REVISION	DATE	DESCRIPTION	BY
1	5/15/70	Rev. levee sta, note file block, deleted maint. dredging - Amend #2	E.M.
DESIGNED:	DRAWN:	CHECKED:	U.S. ARMY ENGINEER DISTRICT, NEW ORLEANS
RPL	CT	RPL	CORPS OF ENGINEERS NEW ORLEANS, LA.
SUBMITTED:			LAKE PONTCHARTRAIN AND VICINITY
DATE: APRIL 1970			CHALMETTE AREA PLAN CHALMETTE EXTENSION
APPROVED:			HURRICANE PROTECTION LEVEE
APPROVED:			FIRST LIFT STA. 770+00 - STA. 995+00
APPROVED:			ST. BERNARD PARISH, LA.
APPROVED:			H-8-24937
APPROVED:			SCALE: SHOWN
APPROVED:			SPRC NO. DACW29-70-B-0181
APPROVED:			DWG. NO. 1 OF 7

**FIRST LIFT LEVEE EMBANKMENT - DESIGN SECTION**

**FIRST LIFT LEVEE EMBANKMENT - DESIGN SECTION**  
FROM STA. 940+00 TO APPROX. STA. 995+00  
NOT TO SCALE

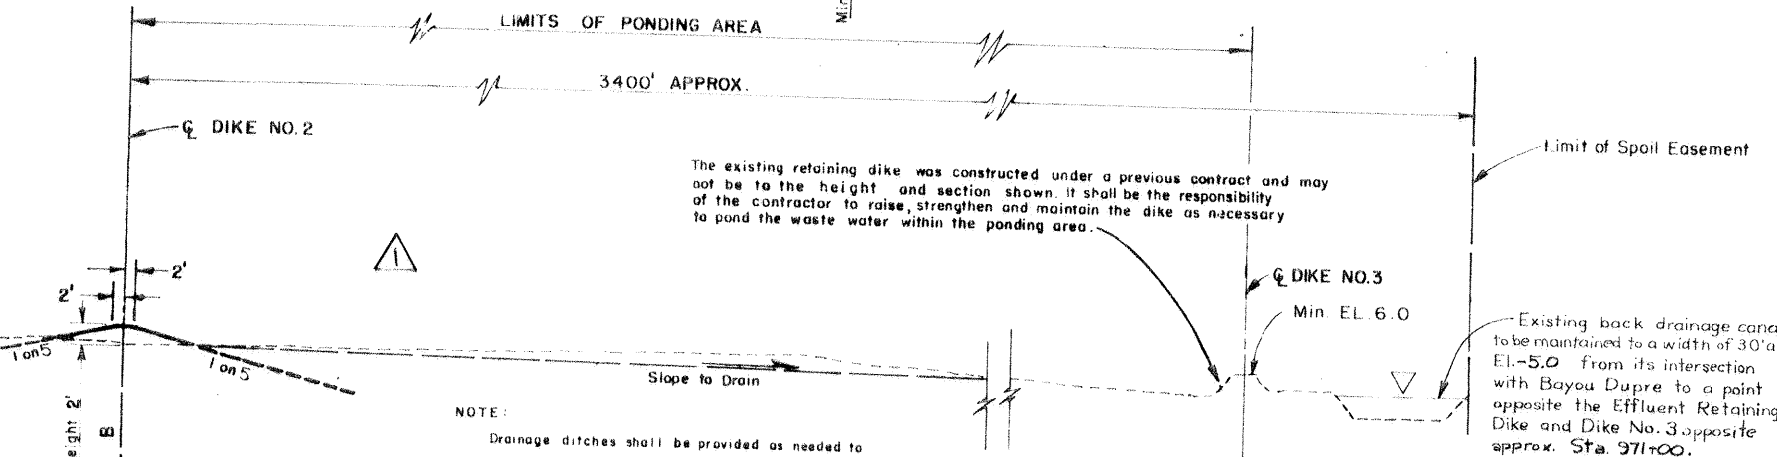
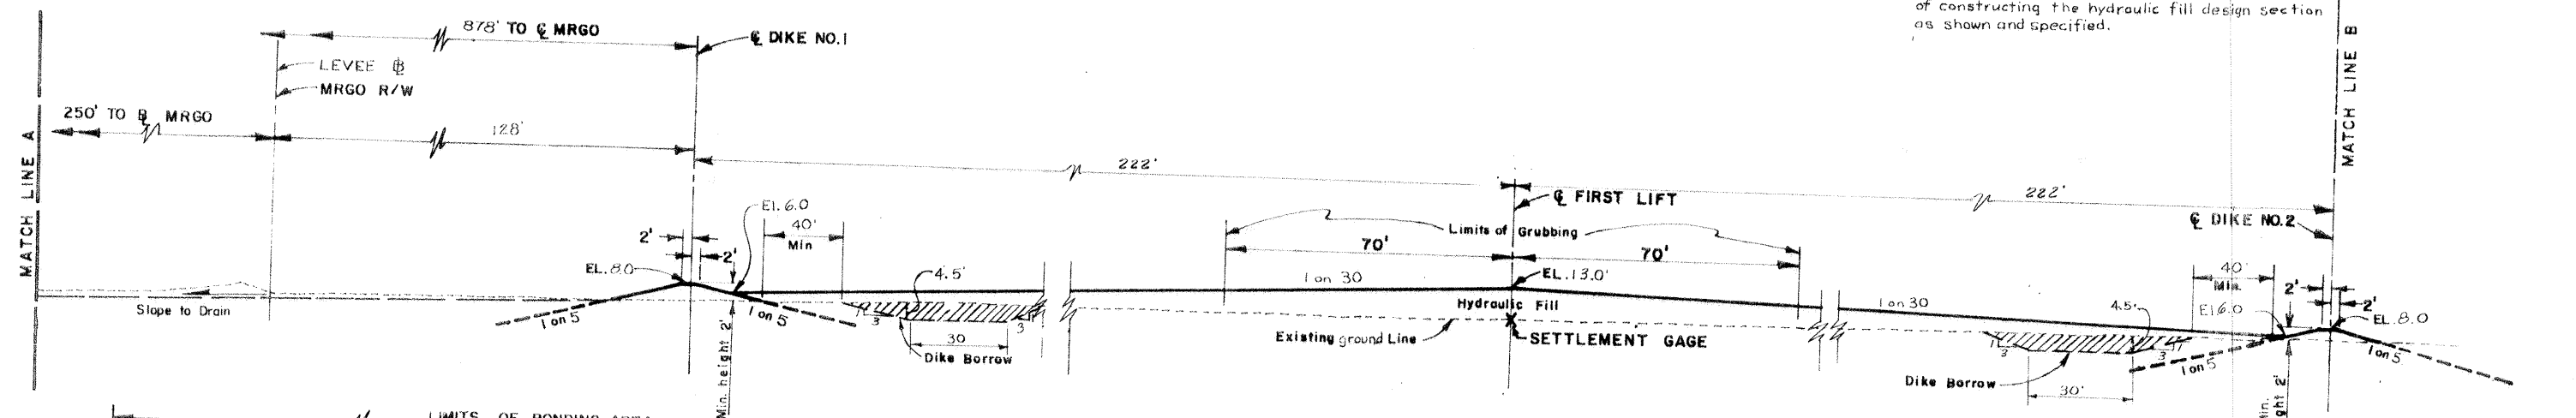
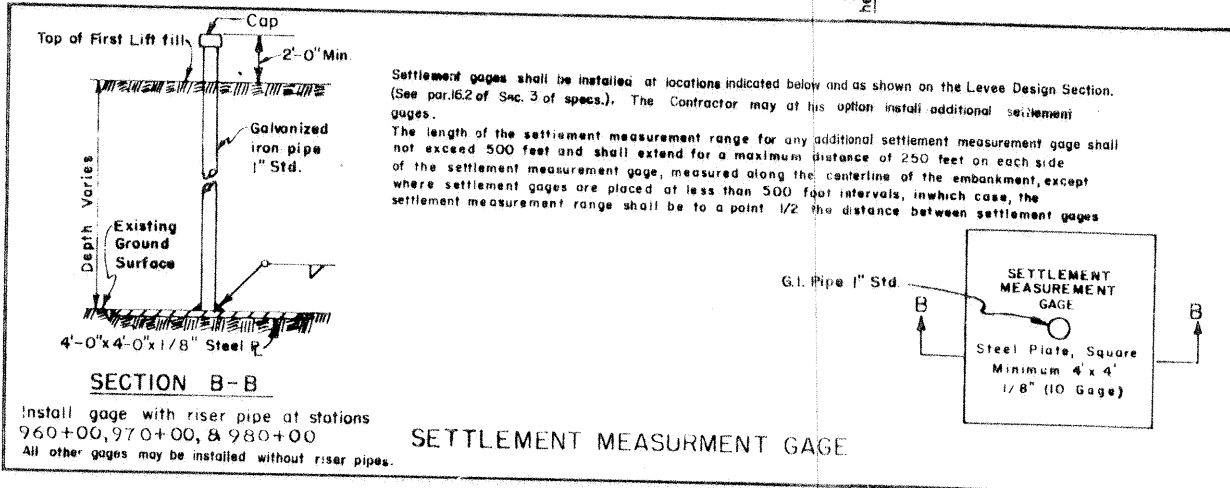
REVISION	DATE	CHECKED BY	CODE IDENT. NO.	SIZE	FILE NO.	BY
RPL.	CT.	RPL.				
5/15/70 Deleted maint. dredging - Amend. #2 EM						
H-8-24937
